工程指示 / 要求簡箋 ENGINEER INSTRUCTIONS(E.I.)

工程指示編號:	EI- 452	修改版本:	-
	HK- 592		
工程編號:	J 852	工程名稱:	亞皆老街上中電
收件人:	生統	發件人:	Eric Liu
工程項目:	偏林箱 後加百葉遮醜鋁板(T1-T3)	日期:	11/04/2022

內容: 按業主SI指示偏林箱位置需要試水
因應偏林箱百葉框需加開孔, 現增加遮醜鋁板修在有偏林箱的百葉上
請按加工圖生產鋁板送地盤安裝用
包裝分座分層分單位打紮
尺寸資料按現場樣板覆尺數
謝謝

Description: Proposal for Drain Hole for Louvre with Plenum Box (Midi's Ref: MST058)

窗尾修好圖定

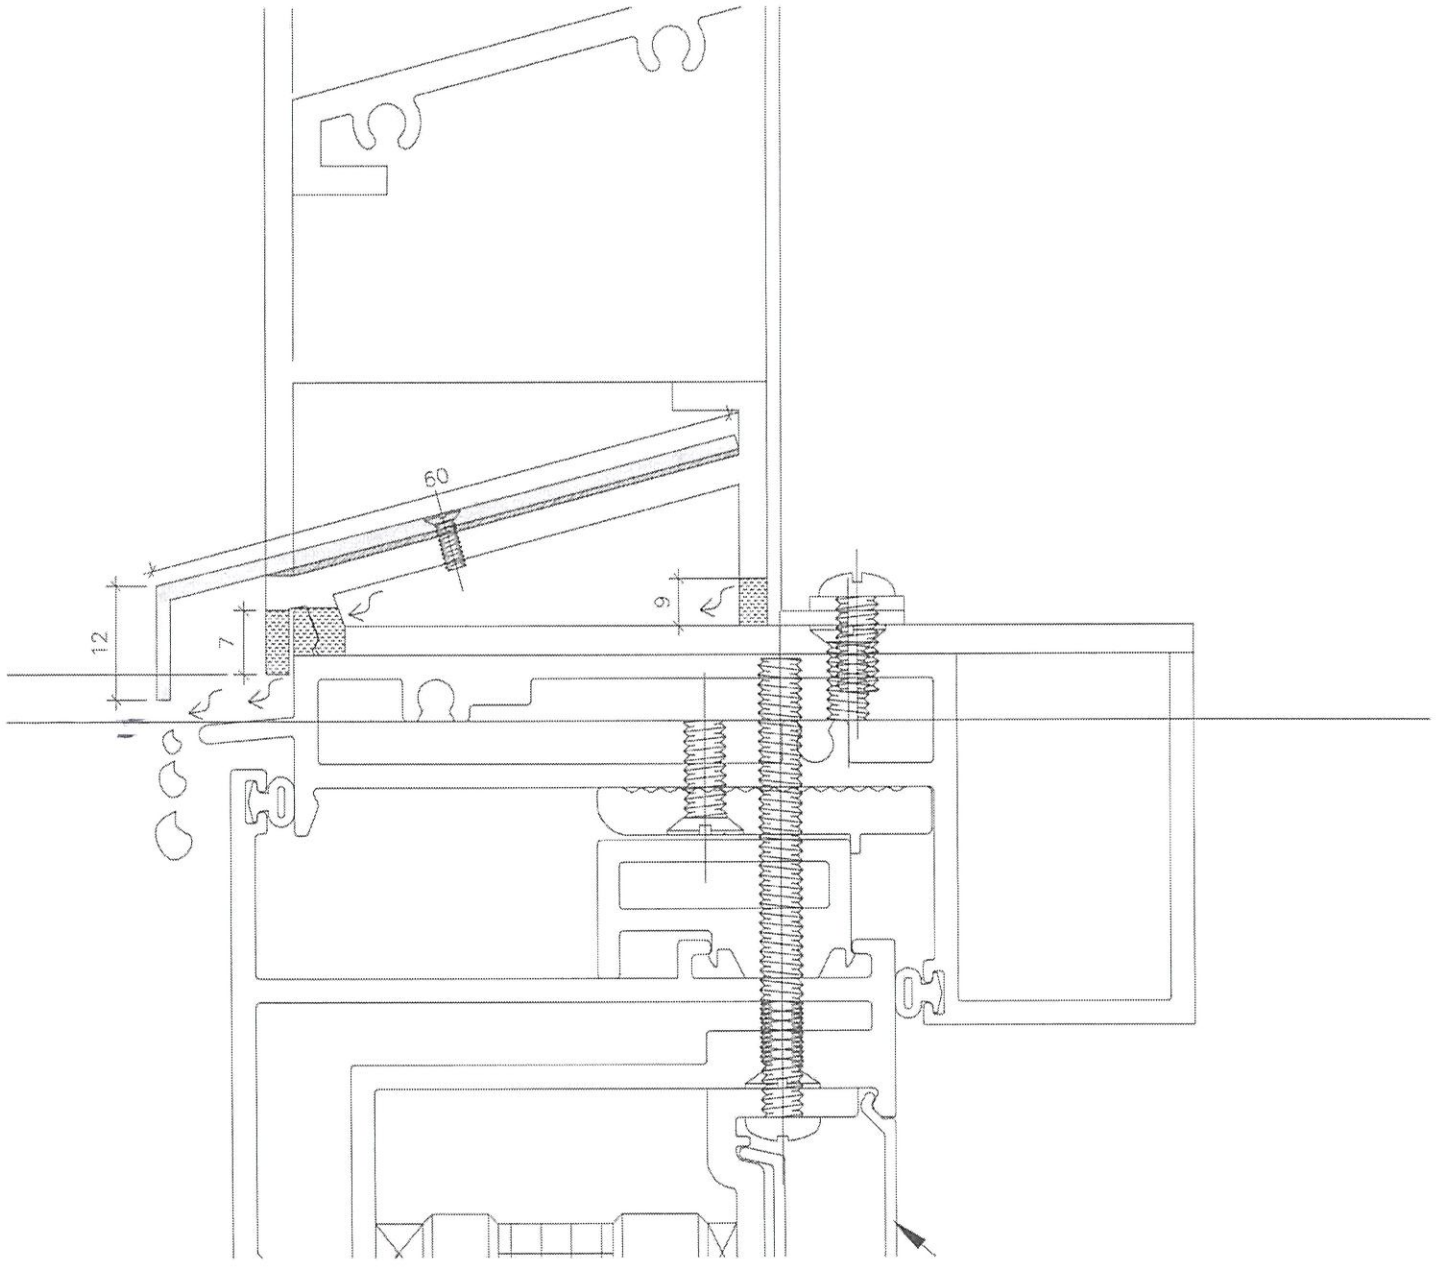
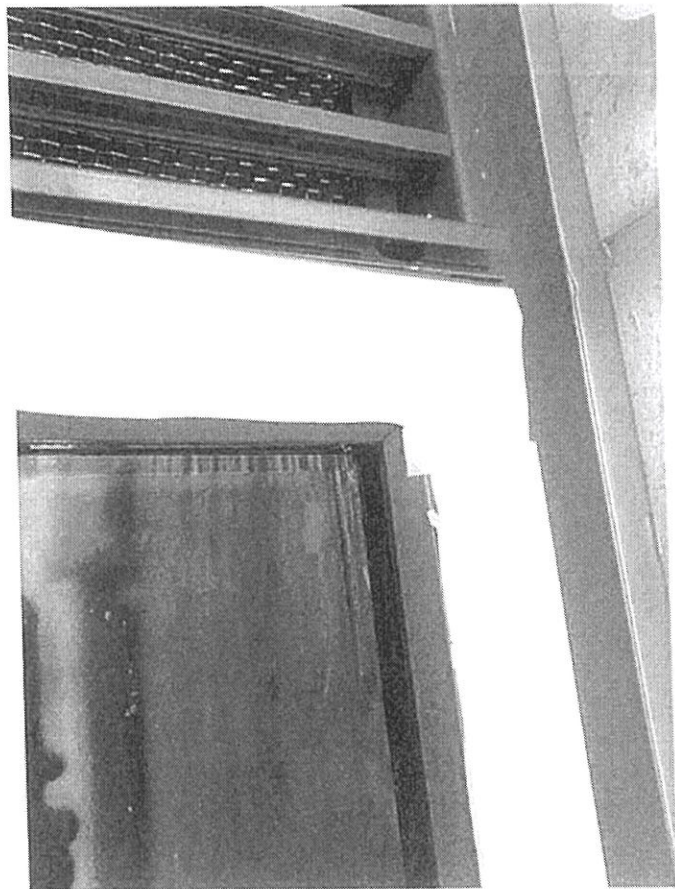
百葉 Plenum box 位置，百葉框上現時已開去水孔的外觀未能符合業主要求，現提供新的方案作改善設計，同時為確保有同樣良好的去水性能，詳細見下：

增加鋁板

1. 現時百葉框上的去水孔會加大至 7x22mm 以及後去水孔為 9x9mm，以增加去水量 (見附頁)。
2. 增加鋁板，用螺絲在左右離邊 20mm 固定在百葉片上(見附頁)，出入數在原有滴水線外，以作遮百葉框上去水孔及提供 FALL 水功能。

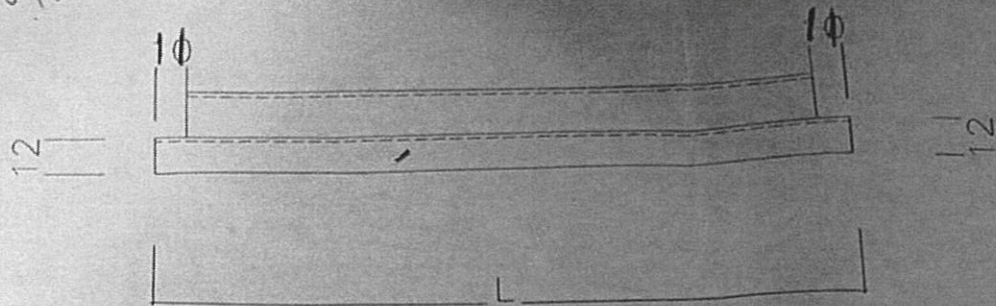
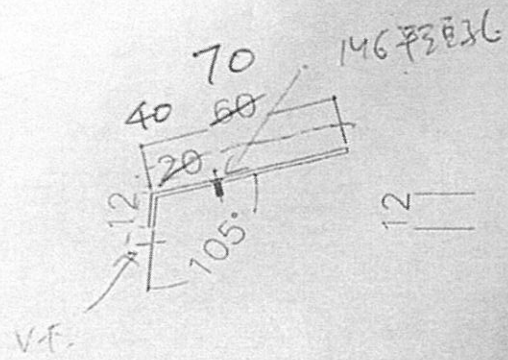
附相為有關 Plenum box 前的百葉長方形去水孔，
現已開此長孔，此去水孔能夠加快去水的效能，
現場位置: T3 2A Kit

請查看效果，能否接受??
